**STAFF REPORT  
FOR THE PLANNING COMMISSION**

**FILE NUMBER:** PUD-16-01/SUB-16-01/ WAP-16-05/VAR-16-01/ VAR-16-02/WRG-16-01

**REQUEST:** 50-lot Planned Unit Development (PUD), Subdivision, Water Resource Area Permit, Class II Variances (2), and Habitat Conservation Area (HCA) permit including Habitat Conservation Area Boundary Verification at 1270 Rosemont Road.

**SITE LOCATION:** 1270 Rosemont Road

**EXHIBIT 5: VERIFICATION FOR MODERATE HCAs ON LOTS 23, 24, 25 and 35.** The pink colored area is a moderate HCA, just like the green colored area, but it identifies the area that the applicant wants to re-classify as "Habitat and Impact Areas not designated as HCAs."

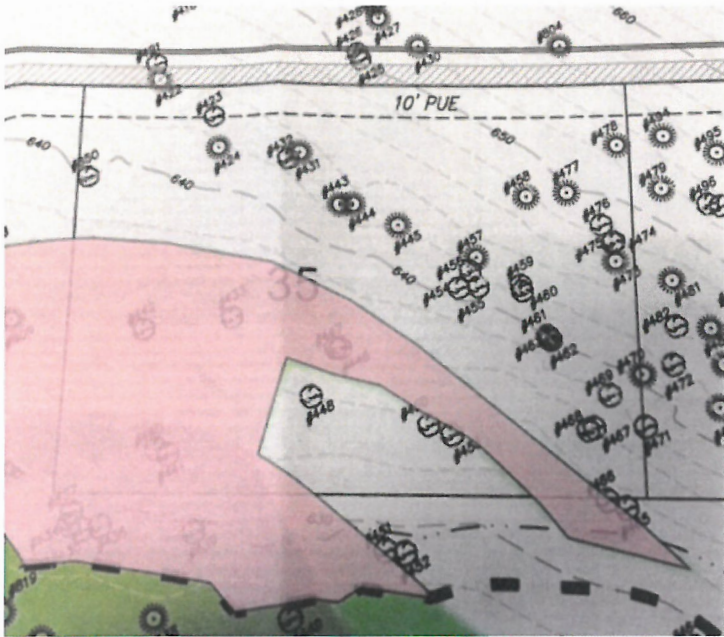
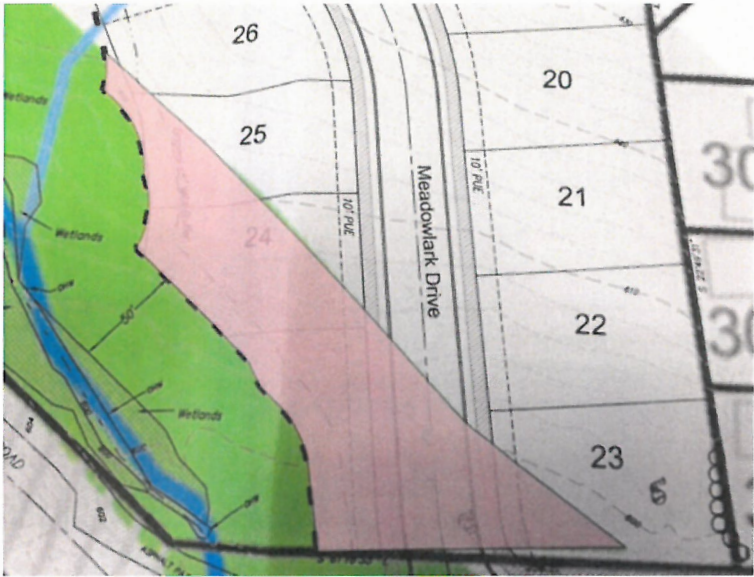
The applicant has provided an HCA delineation by wetland specialist Schott and Associates (August 25, 2016) (page 358) which indicates that the existing HCA boundary is incorrect in that it was based on Metro's misinterpretation of a 2002 aerial photograph of the site. Schott and Associates found that the WRA boundary "*was based solely on tree overstory and a redesignation is appropriate*". The applicant has requested an HCA boundary verification by the Planning Commission to delete the "*Moderate*" HCAs shown in pink on Sheet 3/5 of the applicant's HCA map dated June 2016 and re-designates those areas as: "*Habitat and Impact Areas not designated as HCAs.*" (This would have the effect of removing lots 35 and 23, 24 and 25 from HCA designation.) By that decision, the criteria is met.

The Planning Commission's role is to review the attached findings of Schott and Associates. If the consensus is that the consultant's findings are credible, then the Planning Commission should accept the revised HCA boundary which deletes the "Moderate" HCAs shown in pink on Sheet 3/5 of the applicant's HCA map dated June 2016 and re-designates those areas as: *"Habitat and Impact Areas not designated as HCAs."* If the Planning Commission does not accept the findings of Schott and Associates then the existing HCA boundary would be retained or another boundary could be proposed.

**EXHIBIT 8: TENTATIVE PLAN**

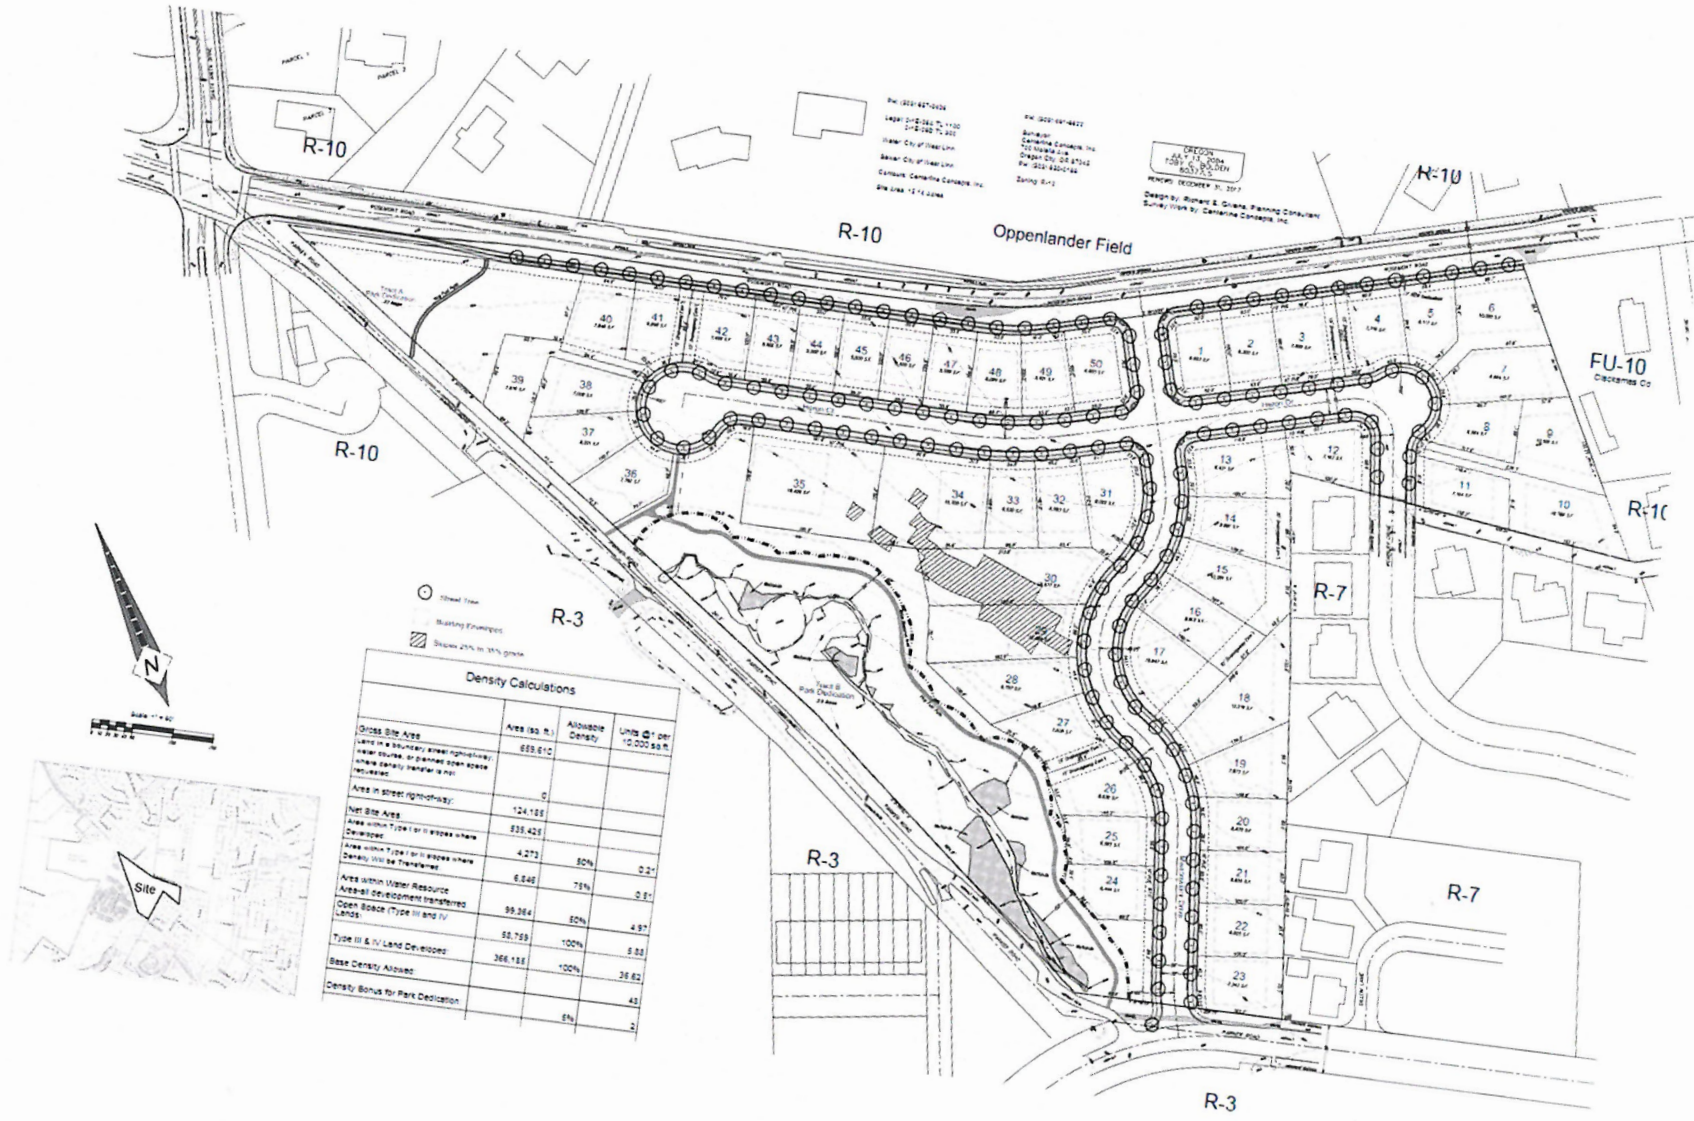
7. **Trail.** The trail, identified on the Tentative Plan as a “hog fuel path”, shall be constructed at least 30 feet from Tanner Creek and the delineated wetland boundary except at the creek crossing.

85.200(A) (16). Interior sidewalks are shown as five feet wide on Sheet 1/3 with a swale. The sidewalks must be six feet wide. Also, is the swale intended to perform a storm drainage function?

1. **Site Plan.** With the exception of modifications as required by these conditions and the HCA Boundary change, the project shall conform to the Tentative Plan (June 2016), the Tree Preservation Plan, the Habitat Conservation Areas, Slope Analysis, Wetlands Plan as identified in Sheets 1/1 to 1/5 respectively and the Utility Plan, Street Profiles and Concept Plan identified as Sheets 1/3 to 3/3 respectively.
